P.O.A.D.P. PLAN
 for
 MACKAY RANCH

Re: Mackay Ranch

POADP # 570

The City Staff Development Review Committee has reviewed Mackay Ranch Subdivision Preliminary Overall Area Development Plan # 570. Please find enclosed a signed copy for your files. Although your plan was accepted, please note the following:

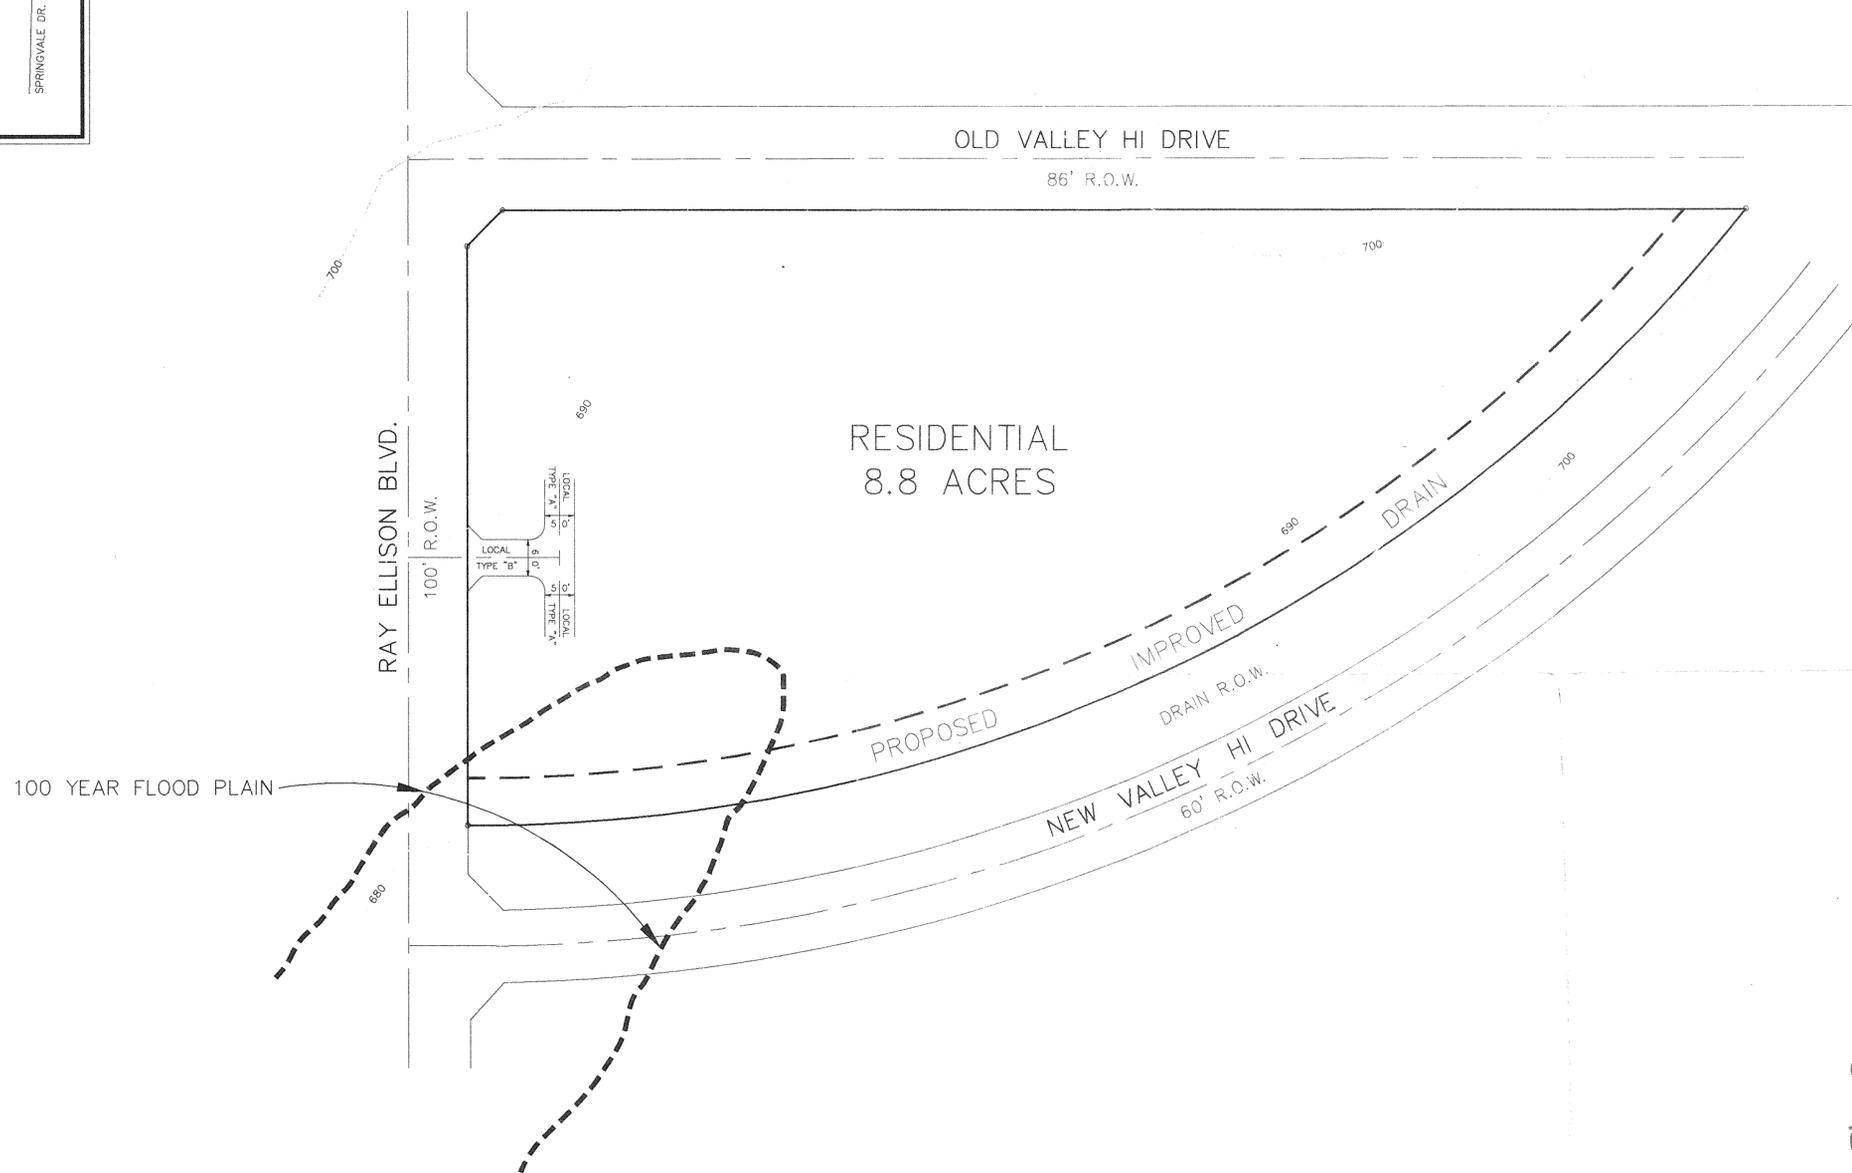
- Based on the topography, a Flood Plain Study and drainage review will probably be required during the platting process.
- This development will need to comply with tree preservation ordinance #85262. For additional information about these requirements you can contact Building Inspections at 207-7102.
